# Access Compliance Report Public Rights-of-Way (Curb Ramps)

Main Street: ROYCROFT\_CT Cross Street: BAINBRIDGE\_AVE Location: SW

ADA ID: RPRK211115120705 Ramp Type: Type 4 - Parallel Initial Pass/Fail: Pass Overall Compliance: No Severity Score: 26

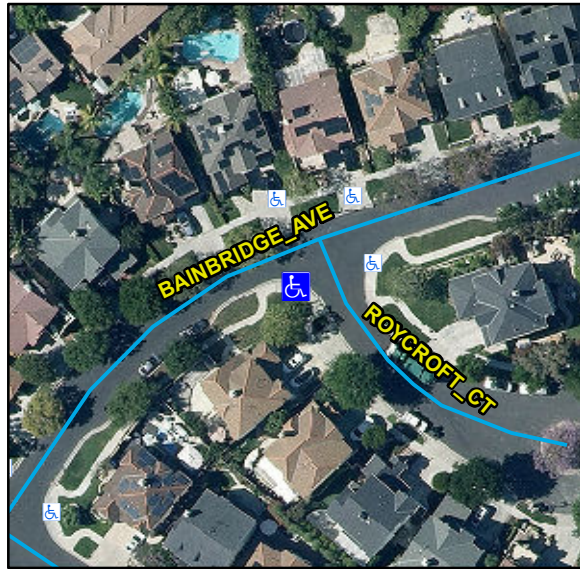
Remove & Replace Curb Ramp With Two New Directional Ramps or Equivalent. Remove & Replace Gutter.

R204.3, R304.5.3, R304.2.1, R304.2.2-Perp, R304.3.2-Para, R305, R304.5.4, STD 1115
